FREDERICK COUNTY PLANNING COMMISSION

CarMax

SP 79-06 (AP #11615, APFO #4824 & FRO #4825)

REQUEST:**Site Plan**

Exhibit #1-Site Plan Rendering

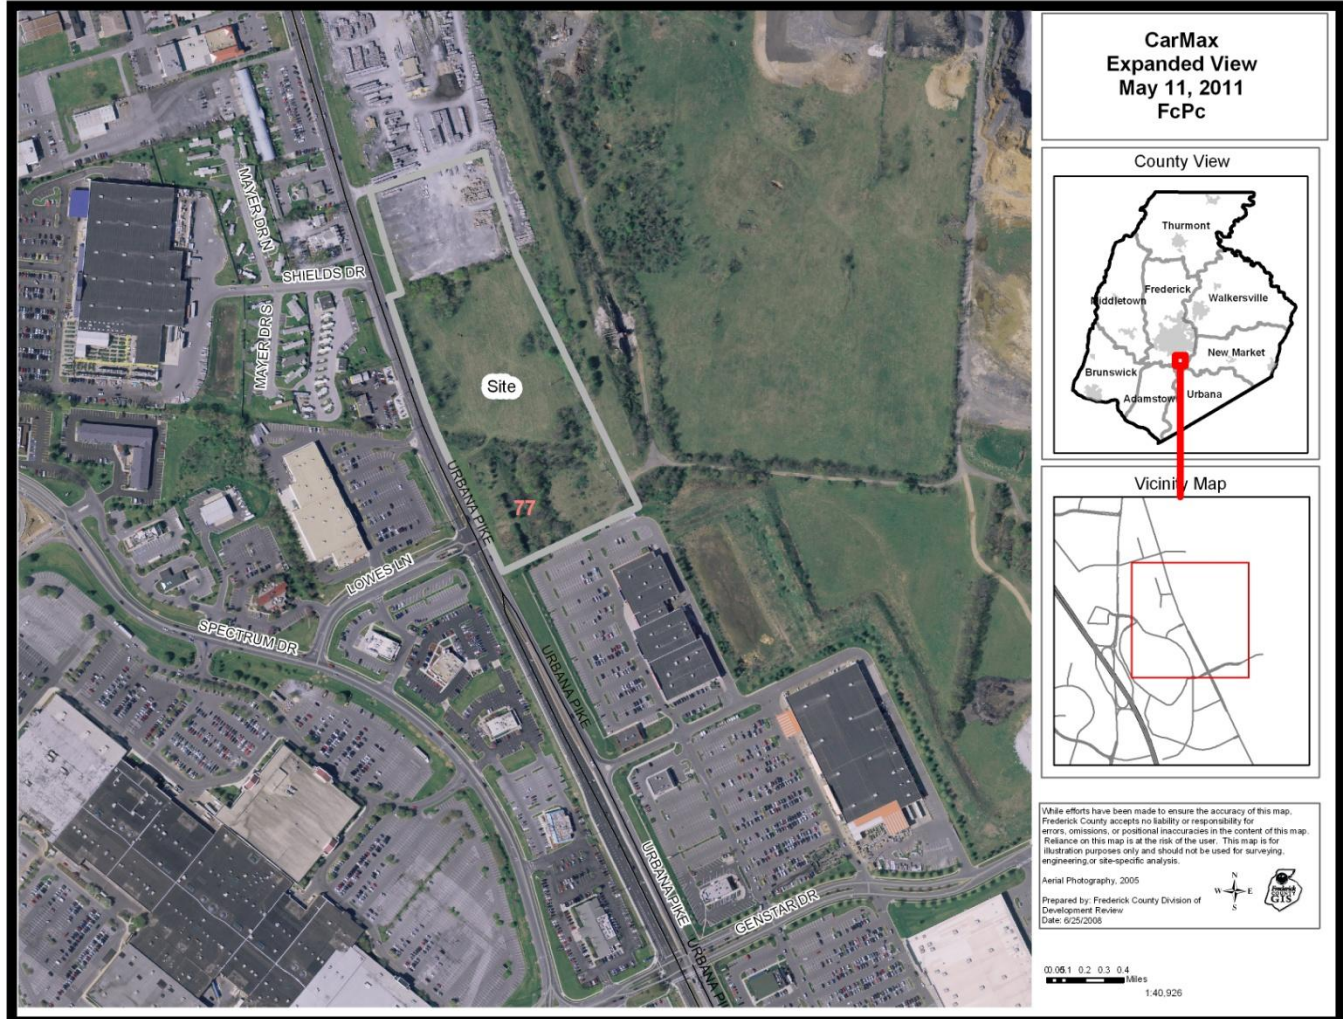
The Applicant is requesting site plan approval for a 36,726 square foot CarMax car dealership, with an accessory automobile repair facility. The 36,726 square foot area is proposed to consist of a 24,092 square foot service building, shown as Section "A" on the site plan, as well as a 9,687 square foot sales building, shown as Section "M" on the site plan. There is also a 2,947 square foot quality control area proposed, shown as "FQC". The Applicant is also proposing a 350-space automobile display area, as well as a 2.2-acre "Sales Staging Area". This plan also proposes a 167-space employee/customer parking area.

Parking: Pursuant to §1-19-6.22 of the Zoning Ordinance, 1 space is required for every 300 square feet of office floor area. Therefore, 50,100 square feet of office floor area requires 167 spaces. Total parking spaces required are 167; the Applicant is proposing 167, including 6 ADA accessible spaces.

The Applicant has shown 1-large (12'x50') loading space to the rear of the principal structure "A" on the site. The Applicant has requested a loading space modification in accordance with Zoning Ordinance Section 1-19-6.210.D. (See attached Exhibit #2). Staff supports granting this modification request.

Lighting: The Applicant is providing lighting by 14 building mounted lights, and 69, 26' pole lights at locations shown on the plan. The Applicant has noted on the plan that lighting will not exceed 0.5 ft/candles at the periphery of the site and lighting will be directional onto the site through the use of shielding and lighting orientation.

Staff has no objection to conditional approval of the site plan.

1. Address all agency comments as the plan proceeds through completion.
2. Approval of Zoning Ordinance Modification requests for the following code sections:
 - a. §1-19-6.210.B Loading Space Requirements
 - b. §1-19-6.220.A Parking Space Requirements and Dimensions
 - c. §1-19-6.220.H.1 Parking Space Requirements and Dimensions
 - d. §1-19-6.400.A.2.c Landscaping and Screening
 - e. §1-19-6.500.B.2 Lighting Pole Height
